**Highland Park Remembrance
2037 McGee Side Road
Servicing and Stormwater Management Report**

**Reference: Highland Park Remembrance 2037 McGee Side Road
Servicing and Stormwater Management Report
City File No.: D07-12-19-0112
Our File No.: 101063**

Subject: Site Plan Control Application – 2037 McGee Side Road - 1st Review Comments

Reference: 2037 McGee Side Road – Site Plan Control Application
Response to Comments – 1st Review
City File No.: D07-12-19-0112
Our File No.: 101063

PROJECT No.	101063
REV	REV # 2
DRAWING No.	101063-PP1

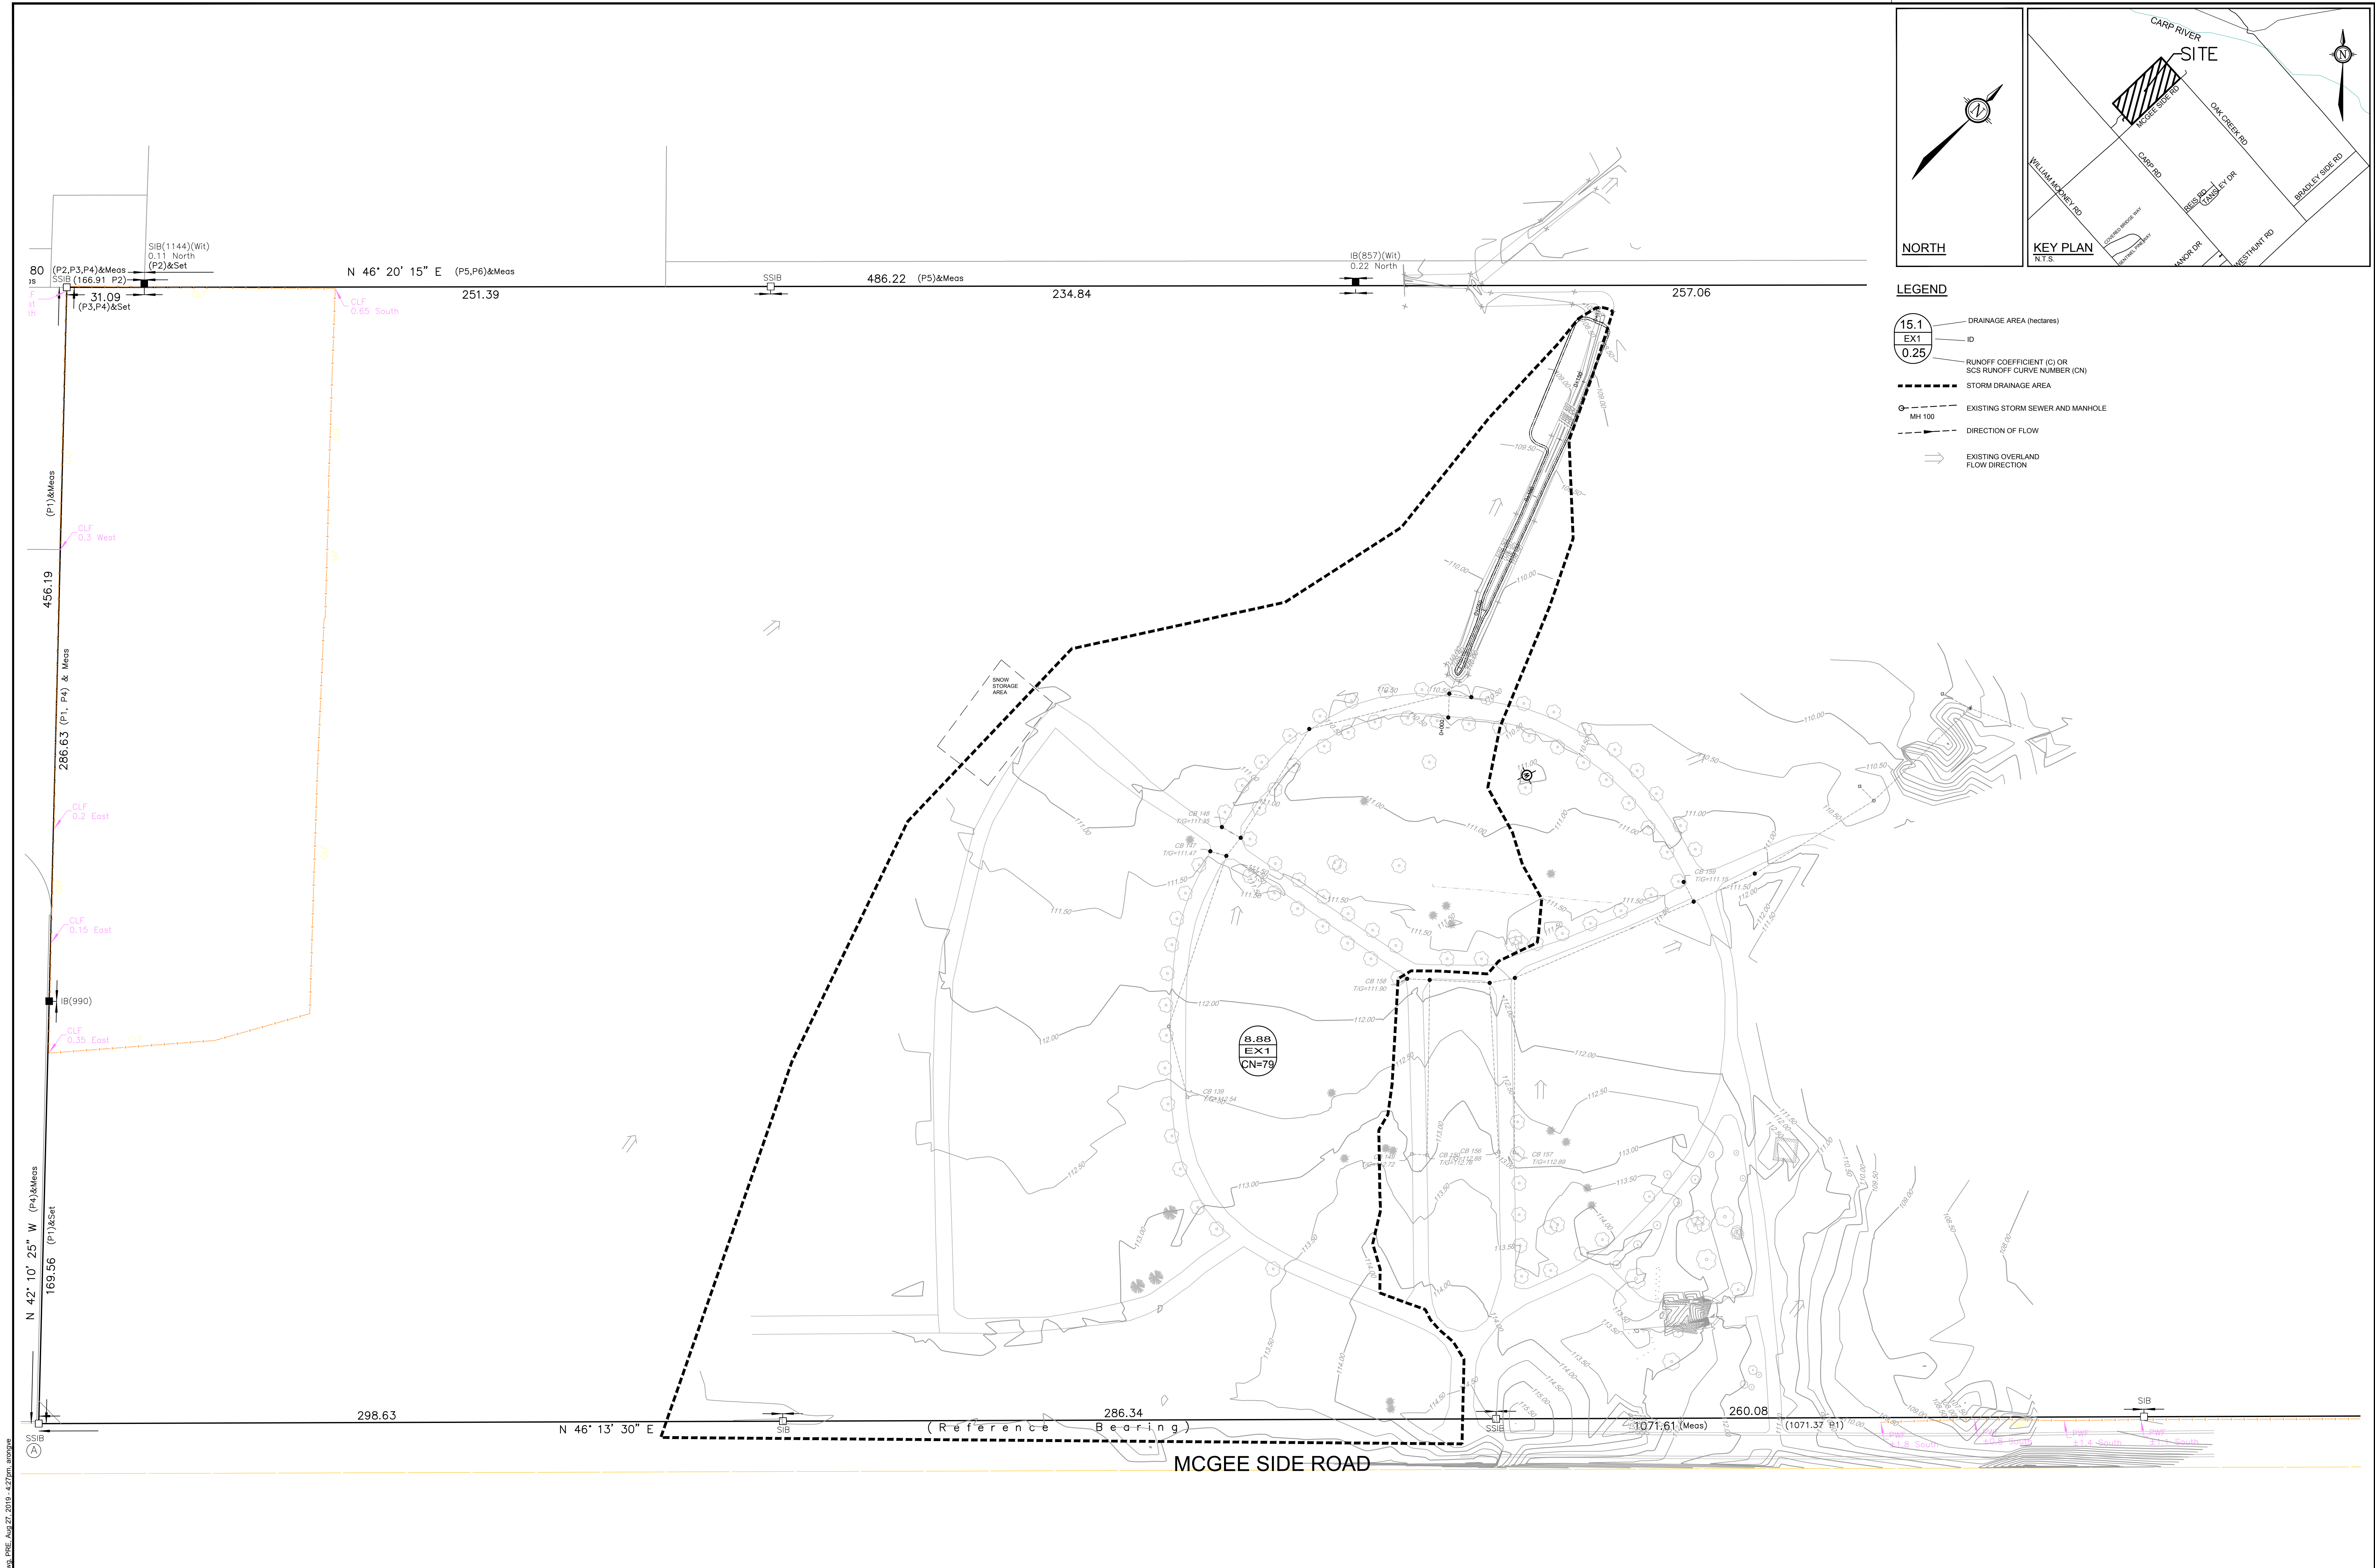
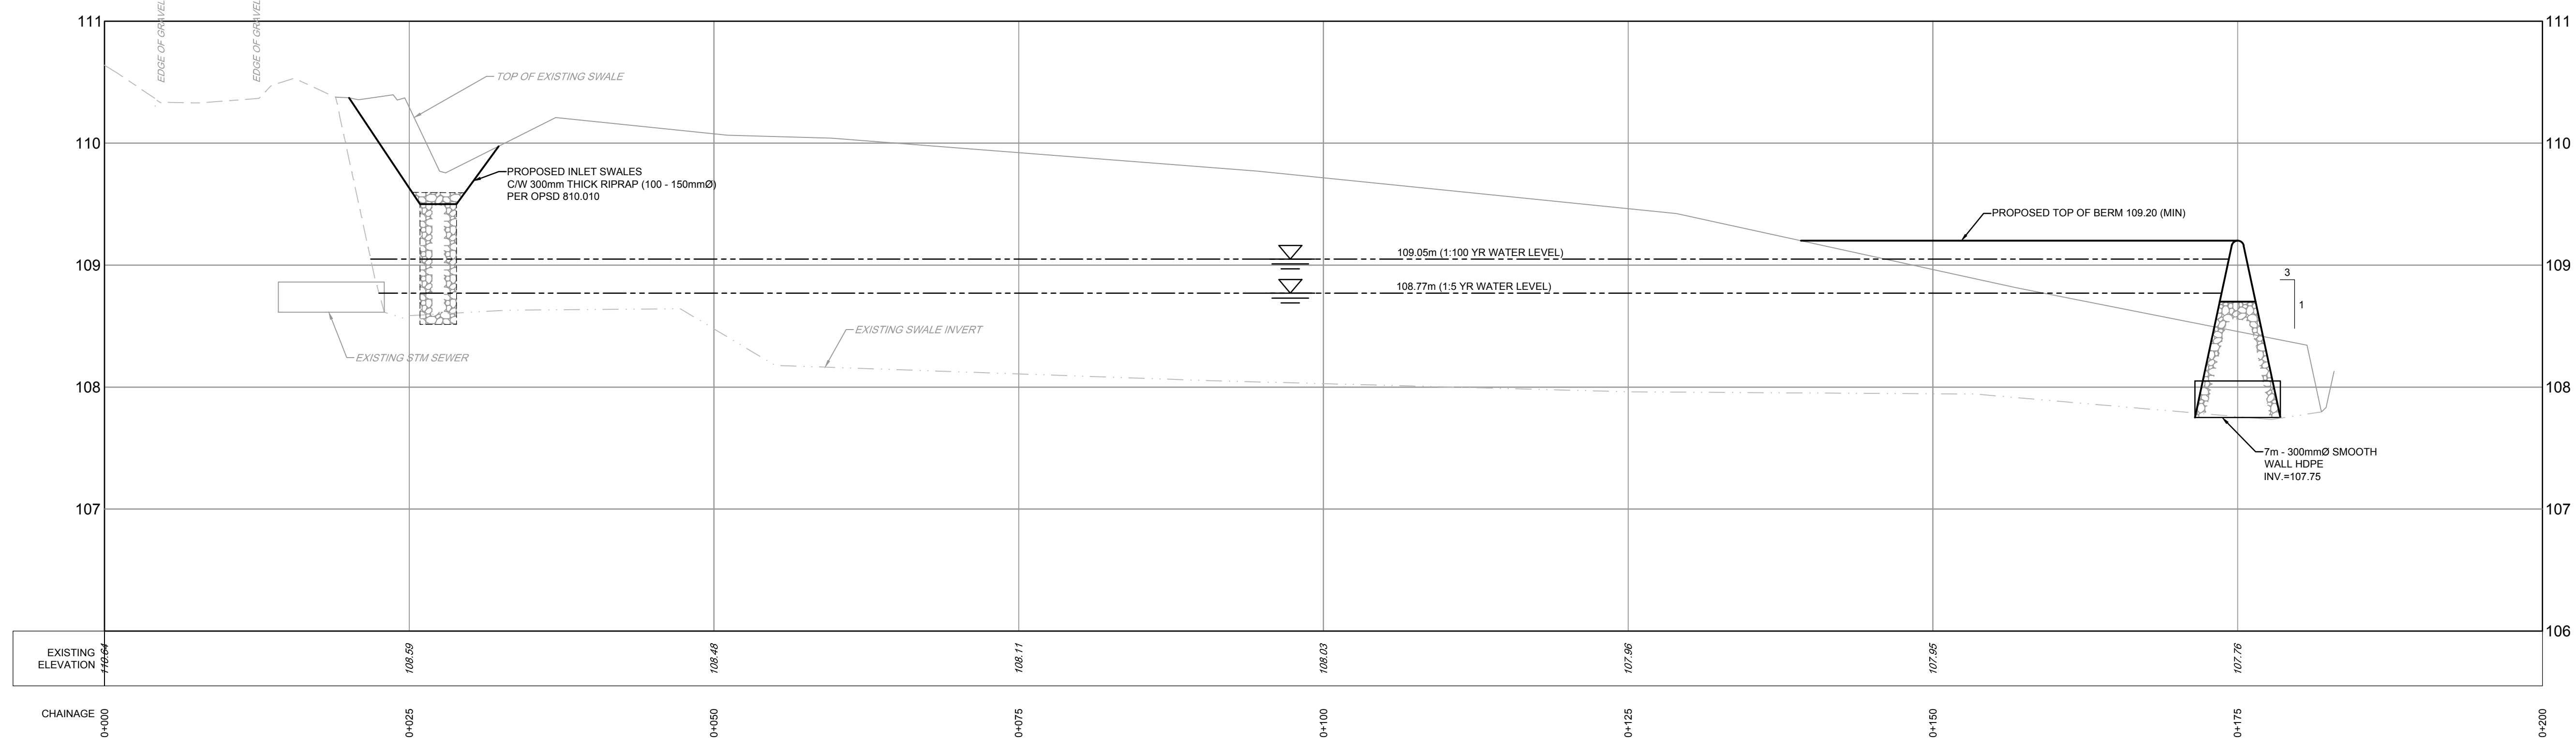
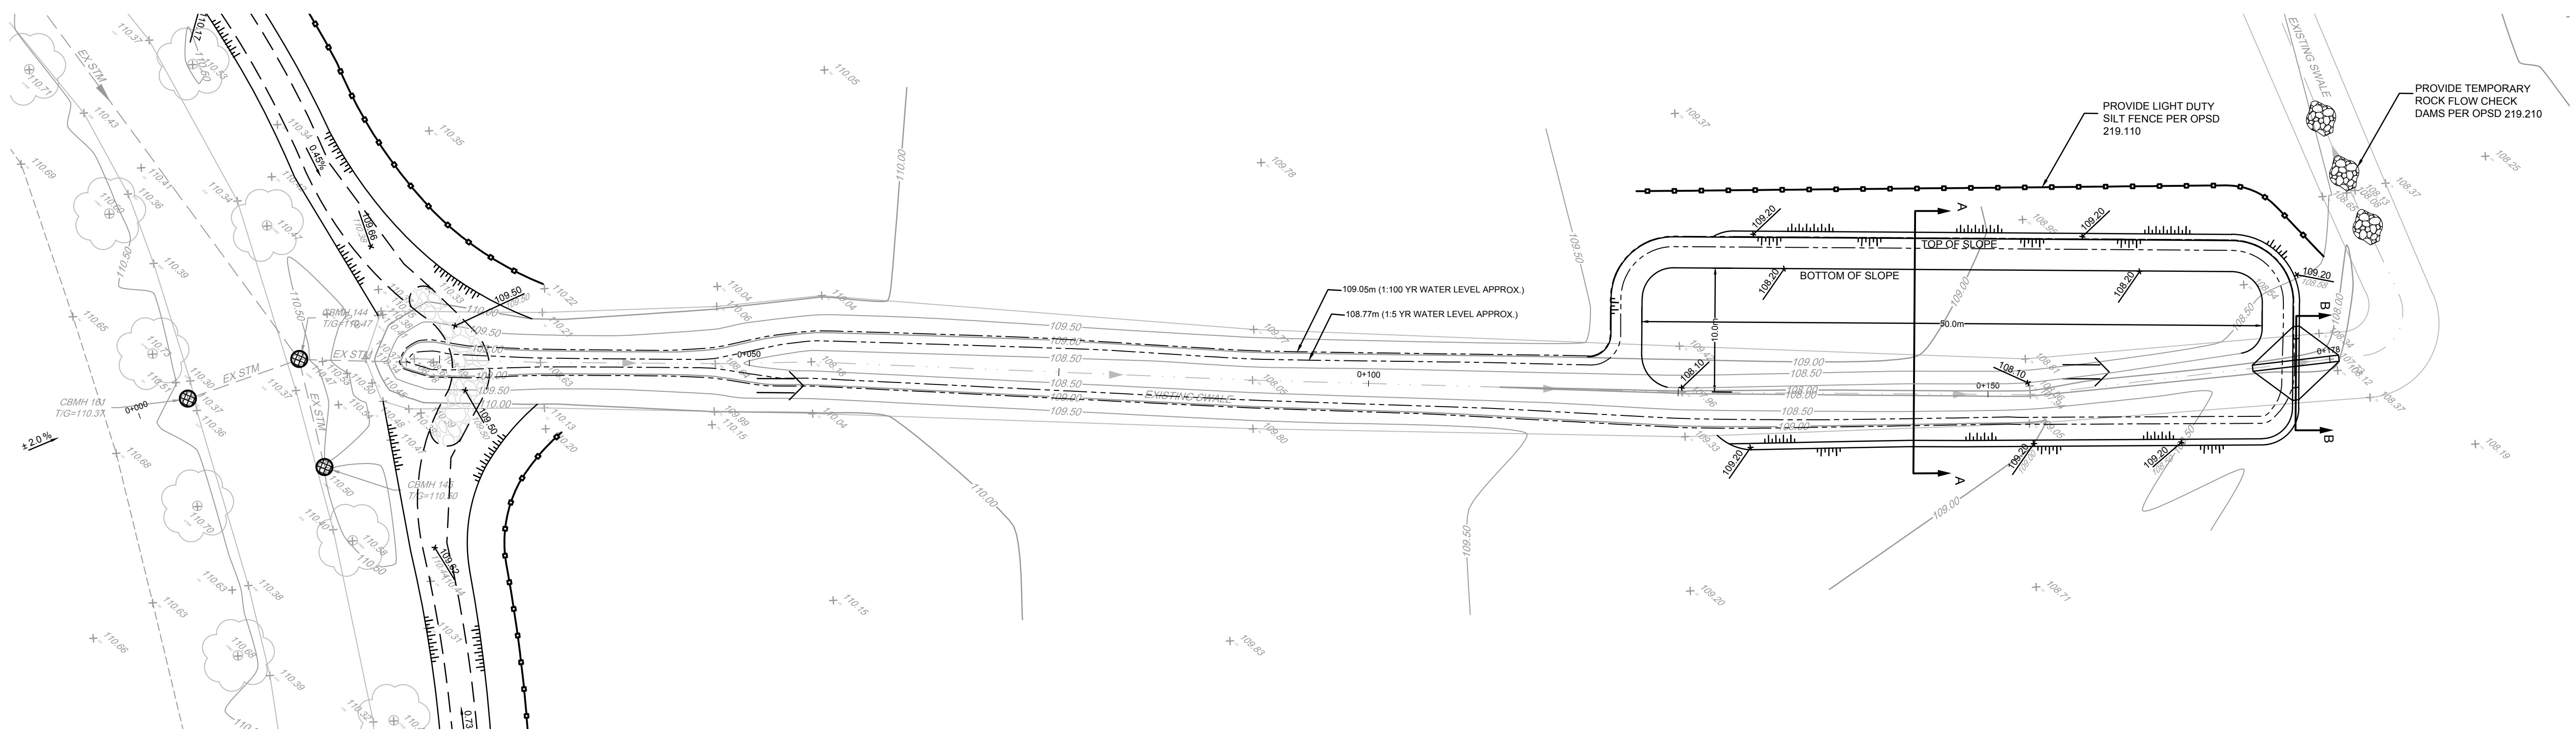
- 1.5. Provide the 5- and 100-year ponding elevations in the outlet ditch

Novatech Response: 5- and 100-year ponding elevations in the outlet ditch have been added to Drawing No.101063-PP1.
